## DESCRIPTIVE REPORT

*Registry No.* ..... **H-11267**

*General Locality* ..... **Approaches to Port Valdez &  
Valdez Harbor**

# Descriptive Report to Accompany Hydrographic Survey H11267

Figure 2. H11267 Junction Surveys.

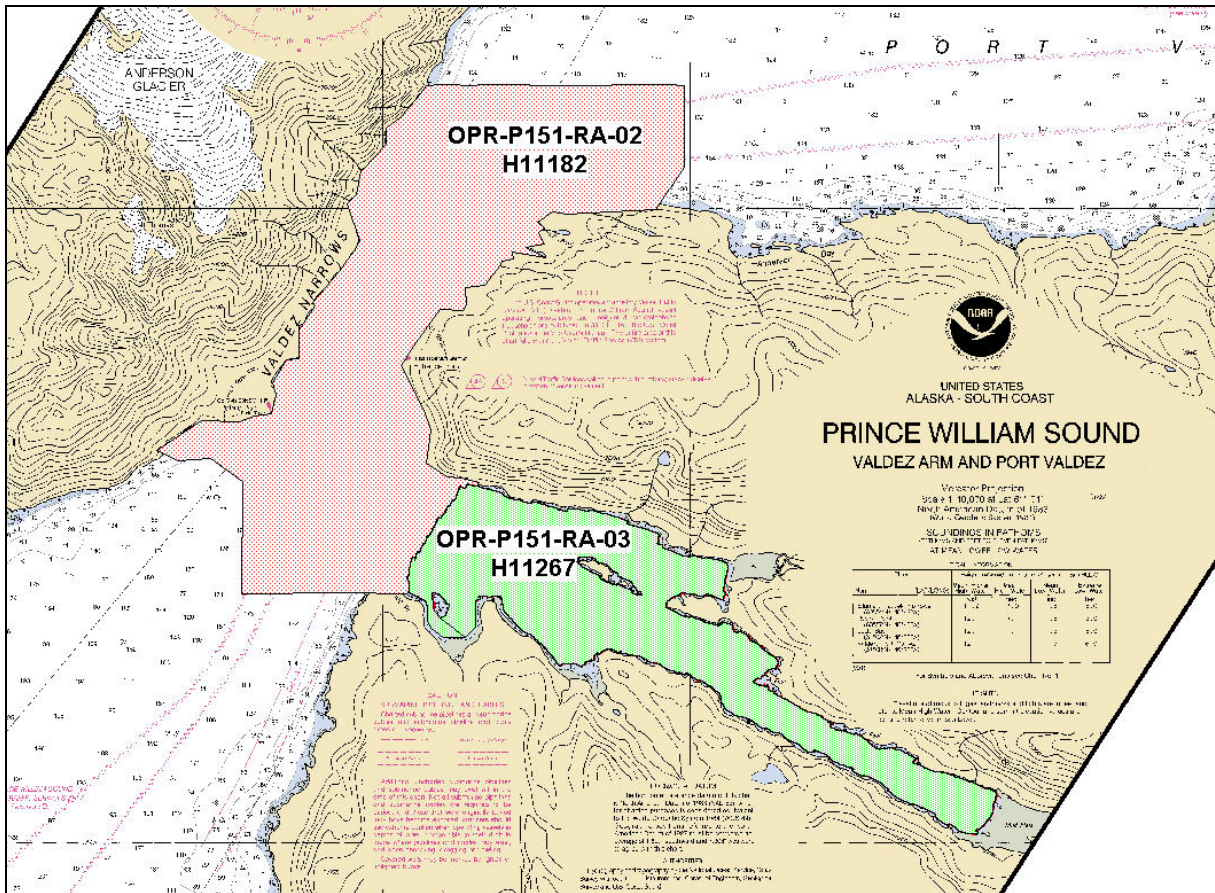
Survey H11182 has been removed from the ship. Final comparisons will be made at the Pacific Hydrographic Branch (PHB) after the application of smooth tides.<sup>6</sup>

<sup>6</sup> Concur with clarification. Junction comparison was made with H11182 during office processing. Sounding and depth curves are in good agreement and a "Joins" note has been added to the smooth sheet.

*Figure 3. H11267 Sound Velocity Problem*

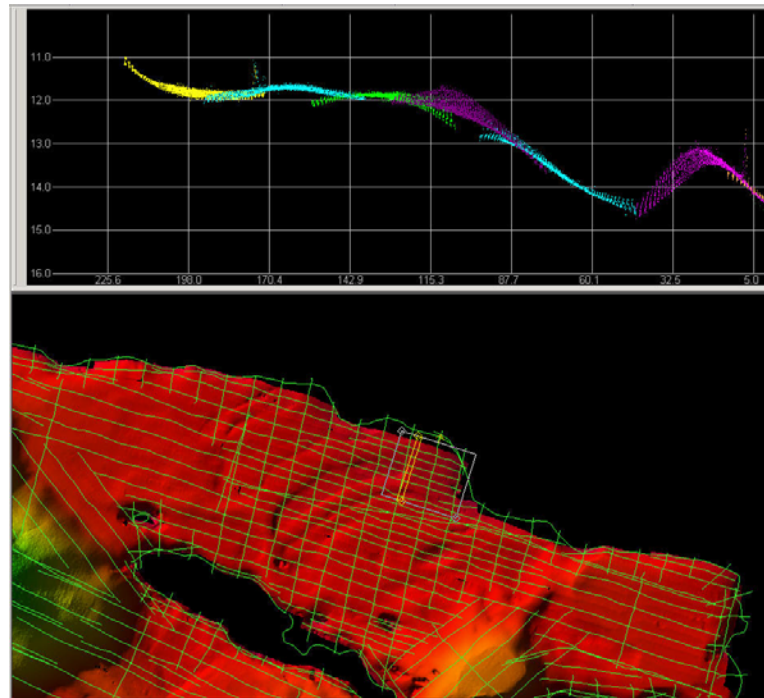
Sound velocity problems up to 0.75m occurred mainly within the northern part of Jack Bay behind the most prominent island where high amounts of fresh water runoff occurred. Figure 3 contains an example of sound velocity problems.<sup>7</sup>

<sup>7</sup> Refer to endnote #4.
